# UNITED STATES PATENT AND TRADEMARK OFFICE

APPLICATION NO.	FILING DATE	FIRST NAMED INVENTOR	ATTORNEY DOCKET NO.	CONFIRMATION NO.
10/502,406	07/22/2004	Pieter Joseph Clara Van Der Wel	NL020059 US	8130

**Office Action Summary**

【図1】

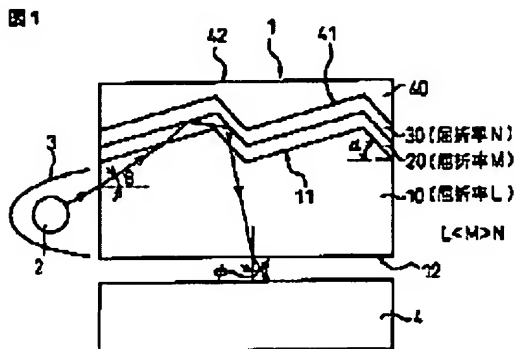
4. Tanaka shows in Fig. 1 and discloses (abstract) a display device comprising an image display panel (4) having a first substrate which is provided with electrodes at the area of pixels (inherent; not shown), and an illumination system comprising an optical waveguide (1) having an exit face (12) facing the image display panel and a plurality of end faces, at least one of which is an entrance face of light, while light can be coupled into the end face of the optical waveguide, the optical waveguide comprising an optically transparent material (20) between two optically transparent layers (10 and 40) the optically transparent material having a higher refractive index (such as 2.2 to 2.4) than the material of the optically transparent layers (refractive index of 1.5), the interface between the optically transparent material and a first of the optically transparent layers at the side away from the image display panel being structured.

As to claim 4, it is clear from Fig. 1 of Tanaka that the interface has a prism structure.
